| Project | IEEE 802.16 Broadband Wireless Access Working Group < http://ieee802.org/16 > | |
| Title | A Common SYNC Symbol for FFT sizes other than 2048 | |
| Re: | IEEE 802.16e D4 Draft | |
| Abstract | Addition of a common SYNC symbol to aid in fast cell search. | |

Figure aaa. Preamble structure (time domain)

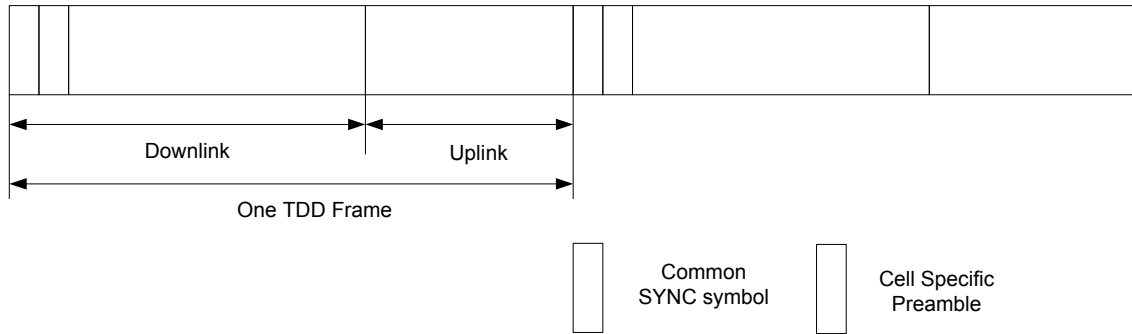
For FFT size other than 2048, ~~only the first k elements of Table 246 shall be used to modulate the DL preamble subcarriers, where k is the number of carriers.~~ the downlink preamble consists of common SYNC symbol and cell specific preamble as shown in Figure aaa. The common SYNC symbol is located at the very first OFDMA symbol in a downlink sub-frame followed by cell specific preamble. All the BSs shall use the same sequence in frequency domain for the common SYNC symbol, and the subcarriers used for transmitting preamble should be the same for all BSs. When the BS is equipped with multiple antennas, the common SYNC symbol shall be transmitted only by antenna 0.

Figure bbb. Common SYNC symbol structure (frequency domain)

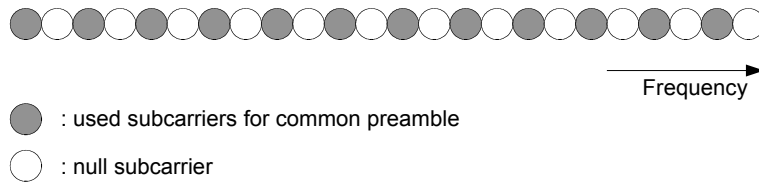
The sequence for the common SYNC symbol is TBD.

The sequence for the common SYNC symbol is in Table ccc.
